REMARKS

Serial No.: 10/076,748

Amdt. dated May 11, 2005

Response to Office Action of January 12, 2005

Fig.16B

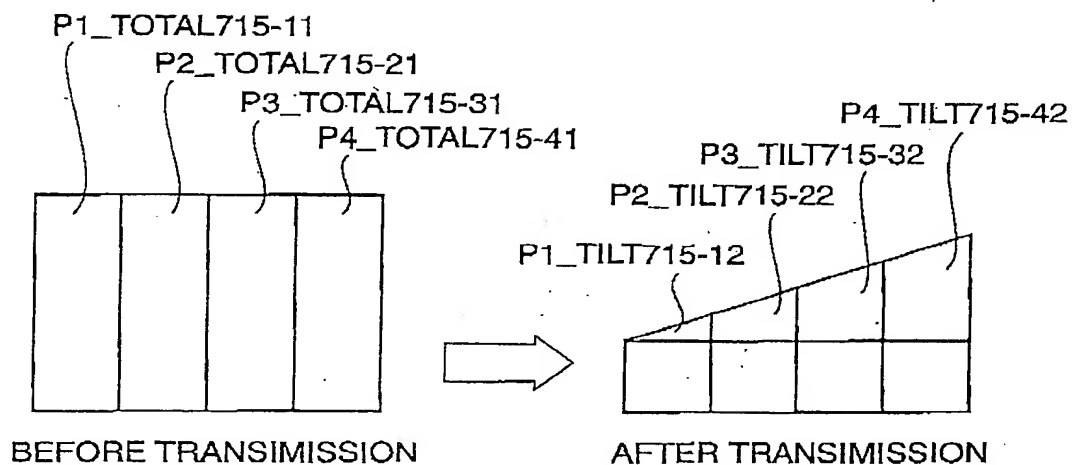
The attached drawing sheet includes changes to Fig. 16B. This sheet replaces the originally filed sheet of Fig. 16B. In Fig. 16B, the triangular portion above the bands P1_TOTAL'715-14 through P1_TOTAL'715-44 has been deleted as shown in red in the annotated version.

Fig. 16B has been amended to be consistent with the original disclosures at lines 8 through 11 on page 23. No new matter has been introduced by this correction.
